Access Compliance Report Public Rights-of-Way (Curb Ramps)

Main Street: ALLBROOK_CT		Cross Street: CLAYMONT_DR		Location:	S
ADA ID: RPRK211020174744	Ramp Type: Type 4 - Parallel	Initial Pass/Fail: Pass	Overall Compliance: No	Severity Score:	25
Codes/Mitigation Info/Possible Solution			Field Measurements/Component Compliance

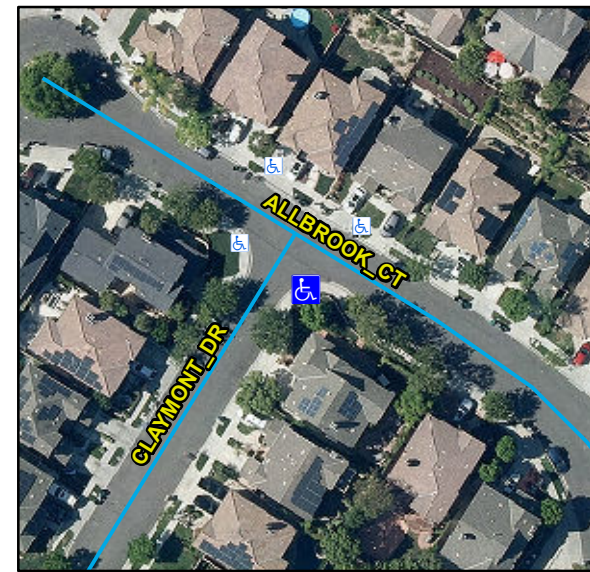
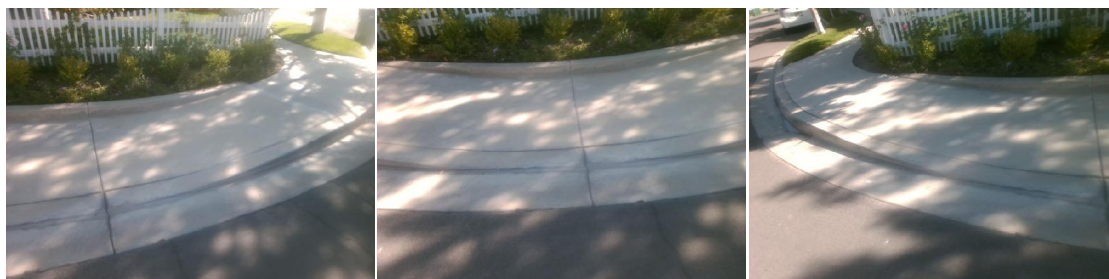
R204.3, R304.2.1, R304.2.2-Perp, R304.3.2-Para, R304.5.3, R305, R304.5.4, STD 1115

N/A	Ramp Inside Crosswalk 1	N/A	N/A	Ramp Inside Crosswalk 2	N/A
	Crossing 1 Slope (%)	3.3		Crossing 2 Slope (%)	4.8
	Crossing 1 Cross Slope (%)	2		Crossing 2 Cross Slope (%)	0.7
Yes	Gutter Ponding	No	Yes	Curb Slope	8.3
Yes	Gutter Lip Height (in)	0		Road Run Slope (%)	2
No	Gutter Run Slope (%)	8.2		Road Cross Slope (%)	0.3
Yes	Gutter Cross Slope (%)	1.8	No	Perpendicular Joint Present	No
Yes	Overall Surface Condition	Acceptable			
	Cross Gutter Present?	No		Spandrel Present?	No
	Replace Cross Gutter?	N/A		Replace Spandrel?	N/A

Remove & Replace Curb Ramp With Two New Directional Ramps or Equivalent. Remove & Replace Gutter.
